Docket Item # 9  
BAR CASE #2009-0295

BAR Meeting  
January 6, 2010

**ISSUE:** Alterations  
**APPLICANT:** Duncan Blair for Patrick Street Associates, LLC  
**LOCATION:** 211 North Patrick Street  
**ZONE:** RB/Residential

**Figure 13: Photos of roof with damaged slate.**

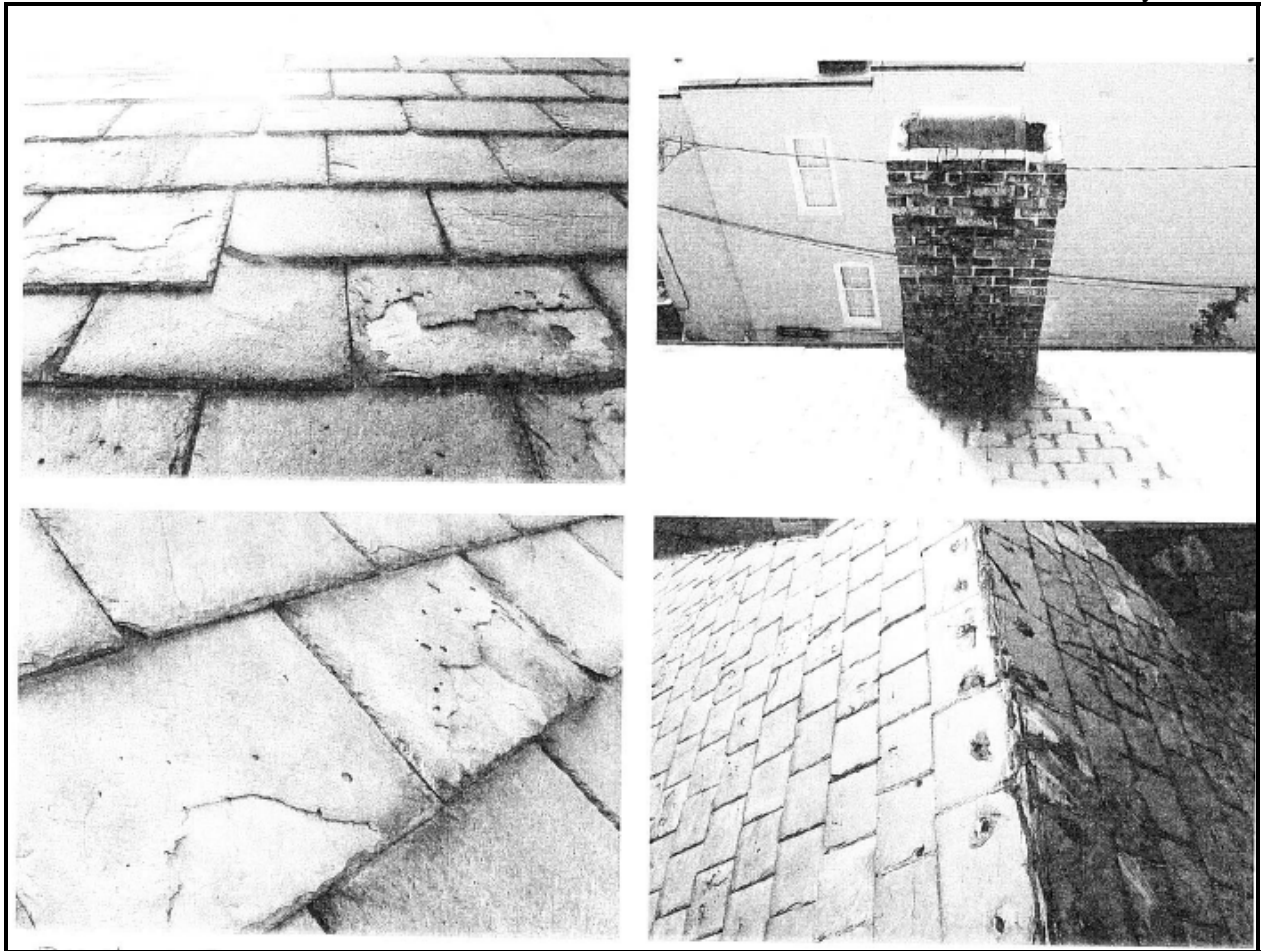
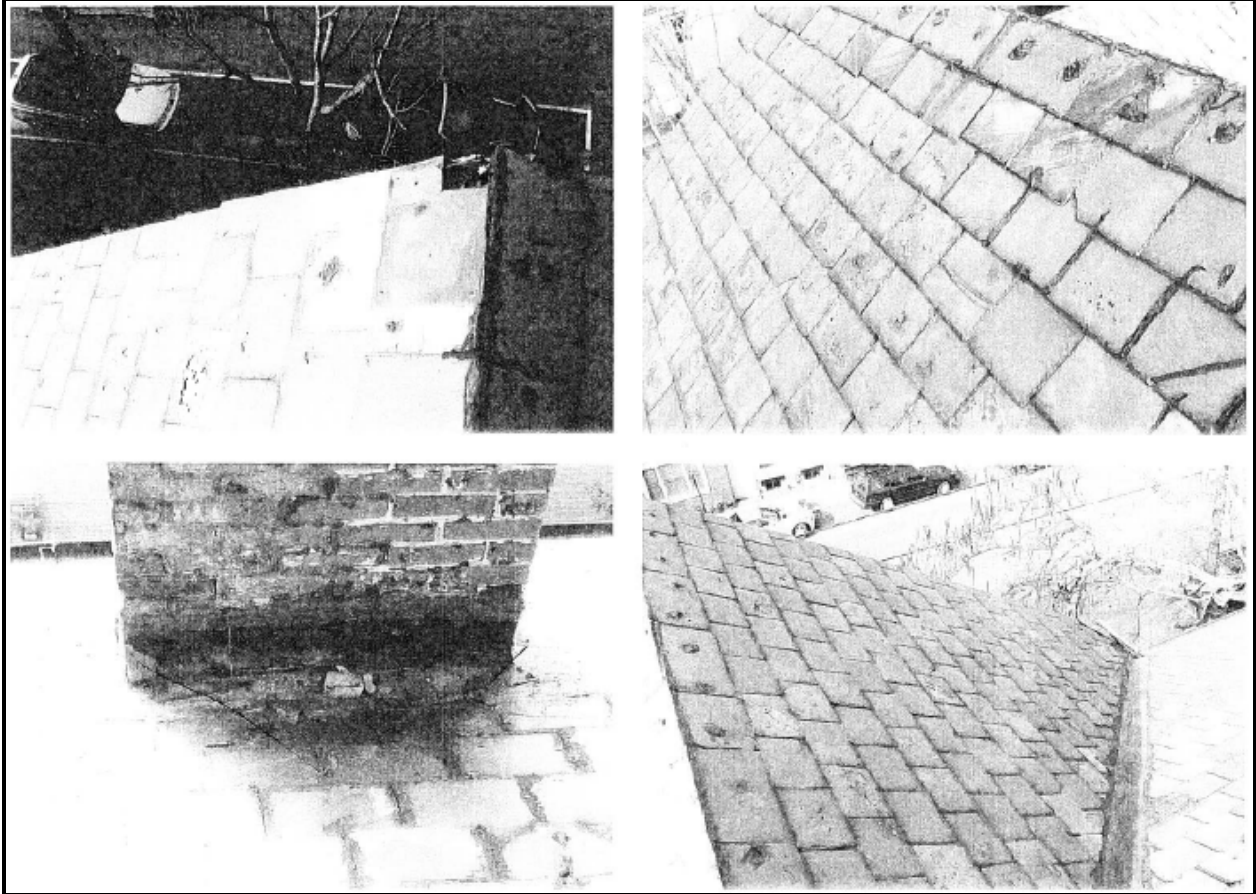
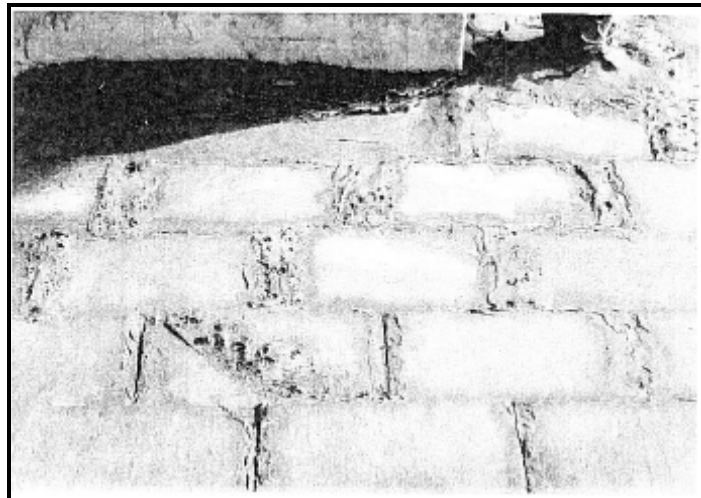
Staff believes that the applicant has demonstrated that the existing slate shingles are beyond repair, and that a new roof is necessary. The average live span of a slate roof is generally 60 to 125 years. Staff believes that the slate roof at 211 North Patrick Street is likely original to the construction of the house, making it approximately 120 years old. The applicant has provided a number of photographs which show significant damage due to cracking and spalling. The National Park Service’s Preservation Brief 29, *The Repair, Replacement & Maintenance of*

*Historic Slate Roofs*, strongly encourages the retention of historic slate and repairing where needed. The NPS brief states that: "If 20% or more of the slates on a roof or roof slope are broken, cracked, missing, or sliding out of position, it is usually less expensive to replace the roof than execute individual repairs." The percentage of damage to individual slates appears to exceed 20% at 211 North Patrick Street.

**IV. STAFF RECOMMENDATION:** Staff recommends denial of the Certificate of Appropriateness to remove the existing slate roof and install a new standing seam metal roof and approval of authentic slate shingles in the same dimensions, color and pattern to match the existing historic roof to the extent possible.

Figure 16: Photo simulation of house with metal roof.

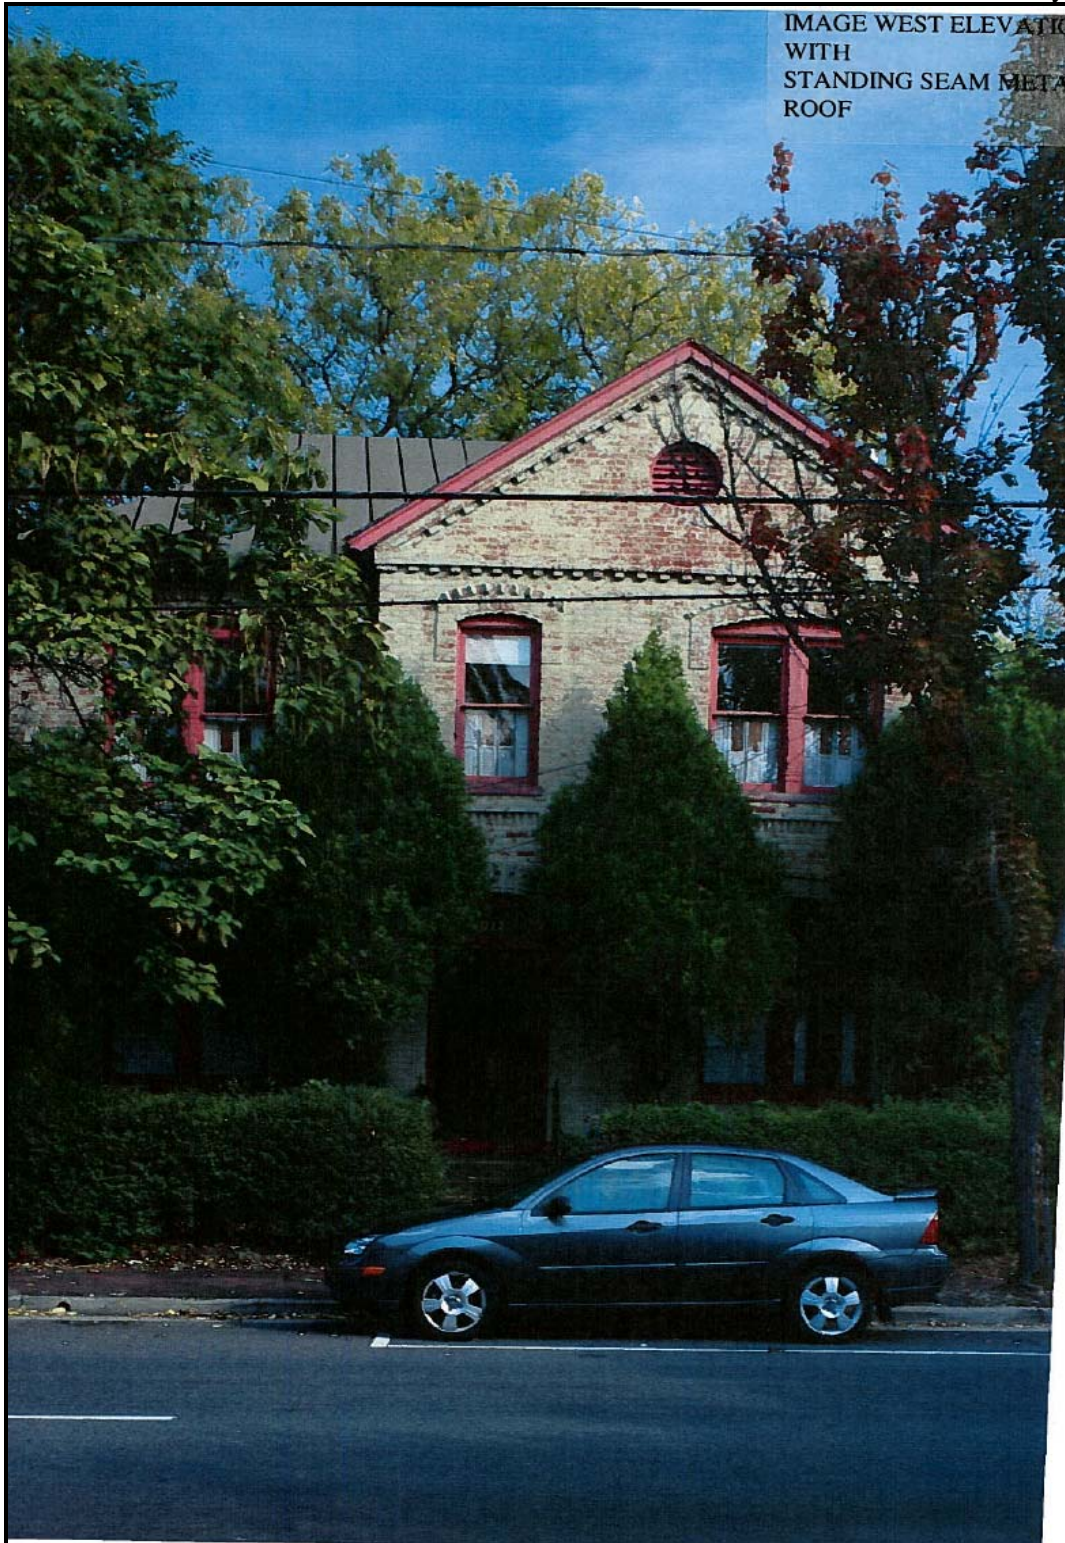
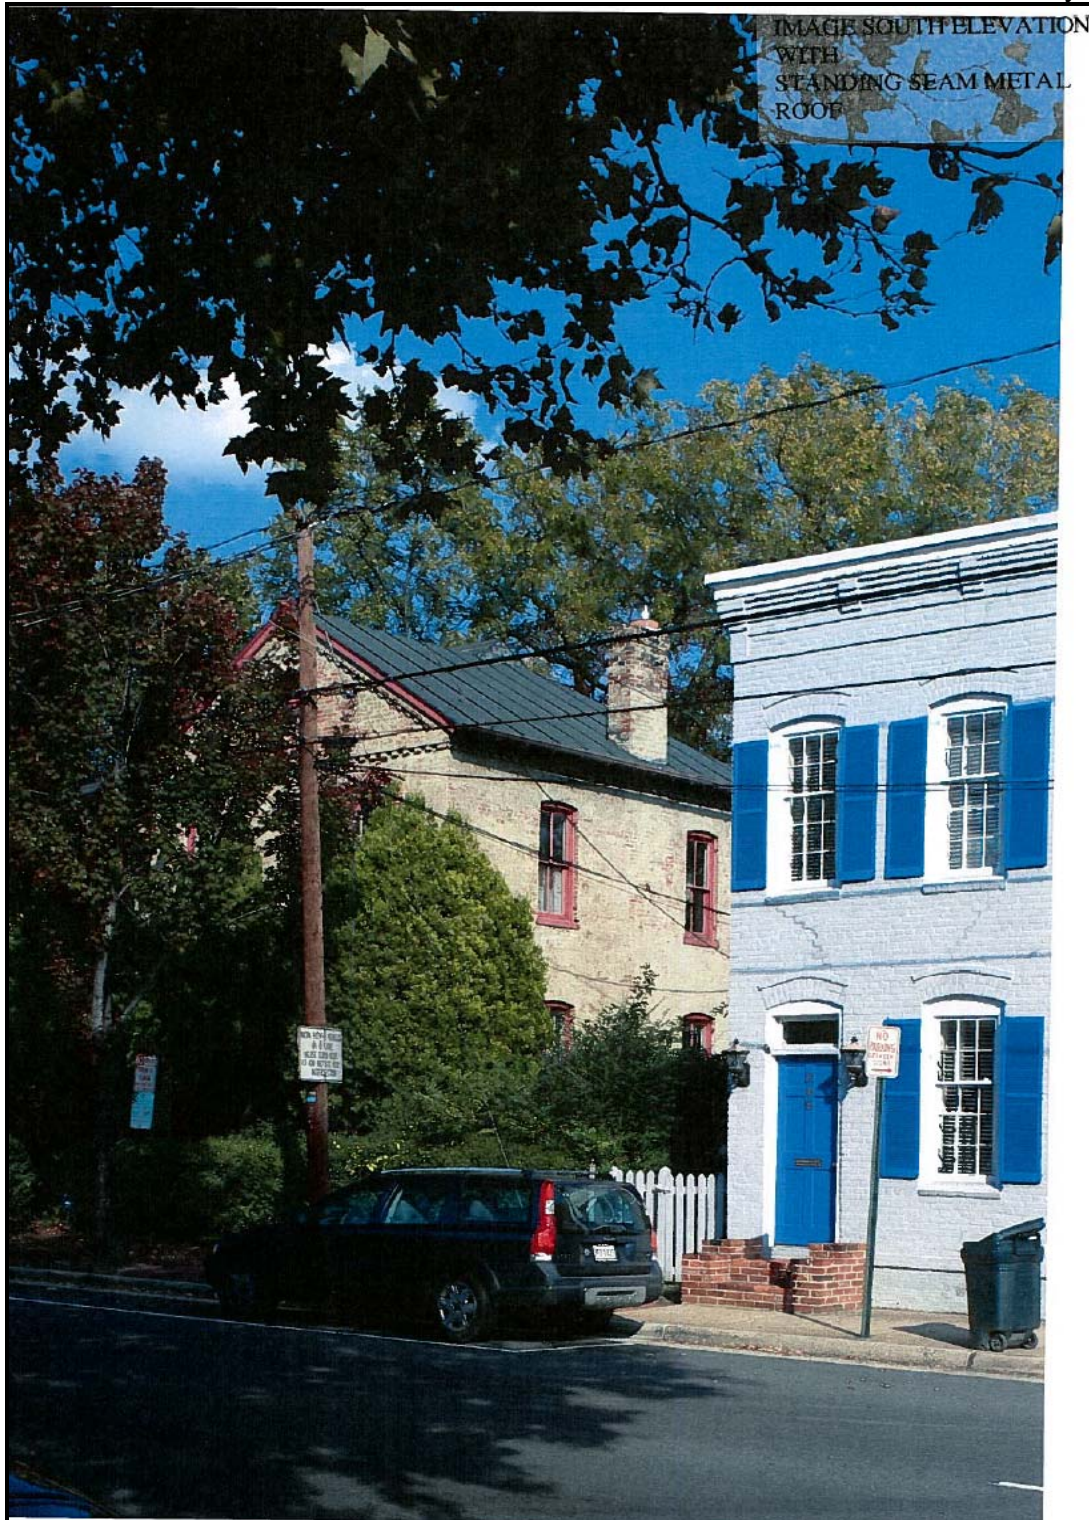
The applicant argues that a replacement metal roof is historically appropriate. While metal roofs were available and widely used during the late 19<sup>th</sup> century when the house was constructed, the use of slate is also relatively common for Queen Anne masonry houses. Another local example of a Queen Anne house with a simple, unadorned slate roof is the French-Lawler house at 517 South Washington Street. The house at 211 North Patrick Street was constructed in a higher style than other houses in the neighborhood and using new slate will help to retain this distinction. As a freestanding building in the Queen Anne style, this building has one of the more complex roof forms found in the district, and with the retention of many of its original features, the house is rather remarkable in the district. The use of individual slate shingles complements the detail and complexity of the roof design; the use of standing seam metal would compromise the integrity of this character-defining feature and the building as a whole. Therefore, Staff finds that the new roof should be slate, matching the size and color of the original and not standing seam metal as proposed by the applicant.
